Well Name: BURCH KEELY UNIT	Well Location: T17S / R30E / SEC 19 / SESW /	County or Parish/State: EDDY / NM
Well Number: 104	Type of Well: OIL WELL	Allottee or Tribe Name:
Lease Number: NMLC028784B	Unit or CA Name: BURCH KEELY UNIT	Unit or CA Number: NMNM88525X
US Well Number: 3001504210	Well Status: Water Injection Well	Operator: SPUR ENERGY PARTNERS LLC

Notice of Intent

Type of Action: Plug and Abandonment

Burch Keely Unit #104
Eddy County, NM
API# 30-015-04210

P&A Procedure

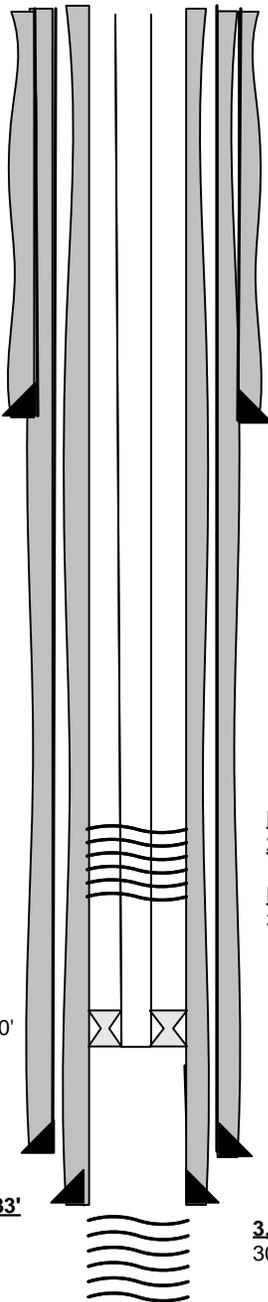
PERF & SQZ 45 SX CLASS
C CMT @ 575'-**346'**
Including Top of Salt

Base of Salt: Perf and sqz ~25sx 850' to 742'

Yates Plug: Perf and sqz ~25sx 1131' to 1020'

CIBP@2223'. Pressure test 500psi, 30mins. Perf and sqz 25sx on top.

CIBP @ 2,700', w/ 125 SX
CLASS C CMT

PERF & SQZ 60 SX CLASS
C CMT @ 2,833'-2,700'
2,650'
